SUBJECT: Provides supplemental info to 970207 ltr in response to matters discussed w/staff during recent telcon re GL 94-03, "Intergranular Stress Corrosion Cracking of Core Shrouds in BWRs."

RE: Nine Mile Point Unit 1
Docket No. 50-220
DPR-63

Subject: Generic Letter 94-03, "Intergranular Stress Corrosion Cracking of Core Shrouds in Boiling Water Reactors"

FIGURE 1: SHROUD WELD MAP

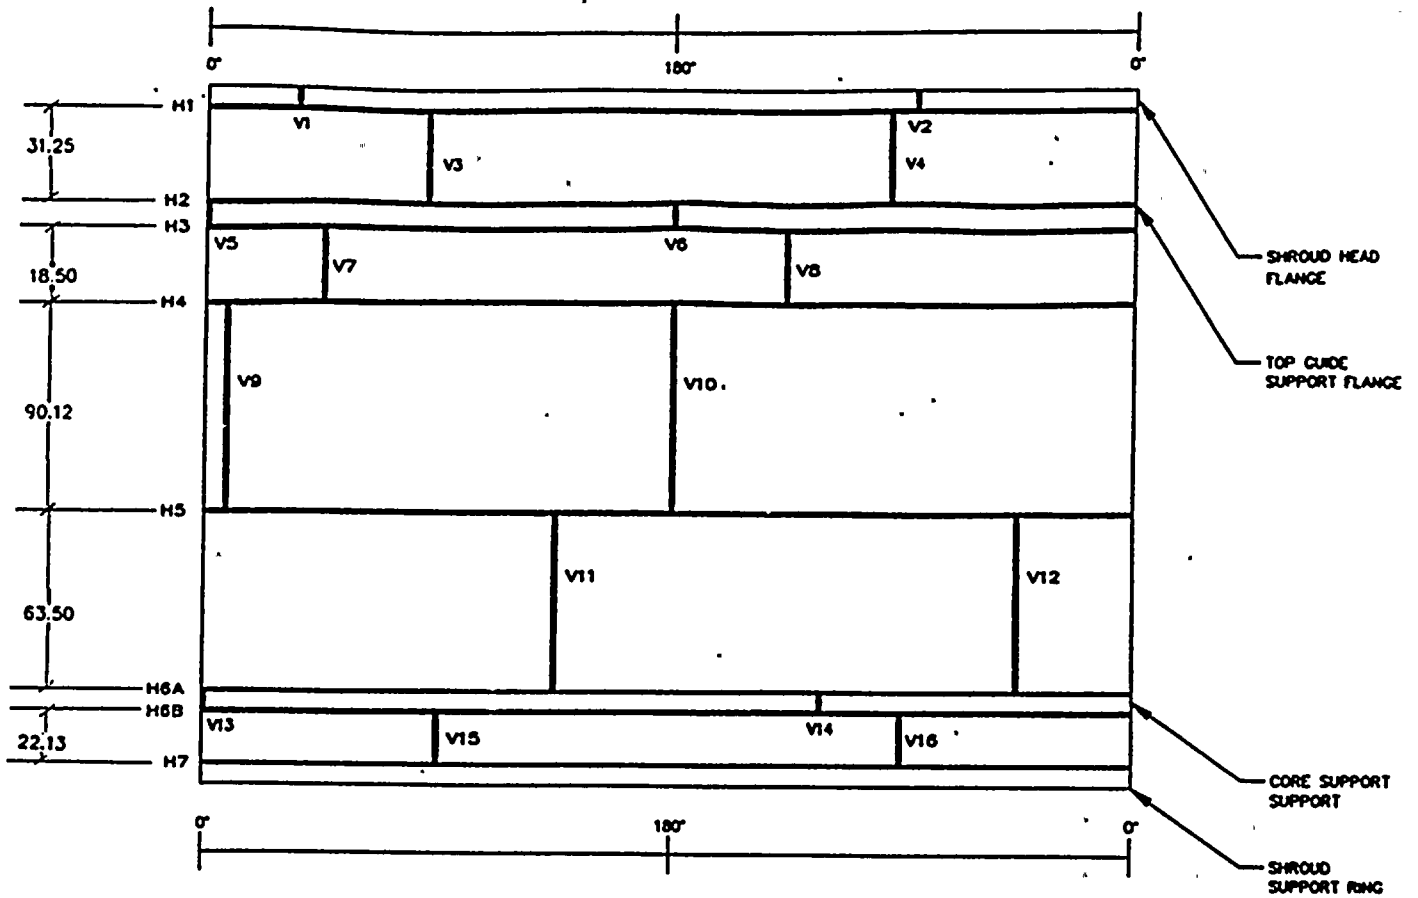
NMPC will perform an enhanced VT-1 of the OD of the entire accessible length of either weld V9 or V10 and a minimum of 23 inches of weld V11 (refer to the shroud weld map in Figure 1). This inspection scope equates to the BWRVIP-07 recommended 25% of the equivalent length of all shroud vertical welds. For NMP1 the equivalent length of all vertical shroud welds is approximately 451 inches, therefore a minimum of 113 inches of vertical weld will be inspected. Following completion of the baseline inspection and assuming no cracking was identified, NMPC plans to follow BWRVIP-07 for shroud

V3, V4-12", V7, V8-10", V9, V10-27", V11, V12-16", V15, V16-11"
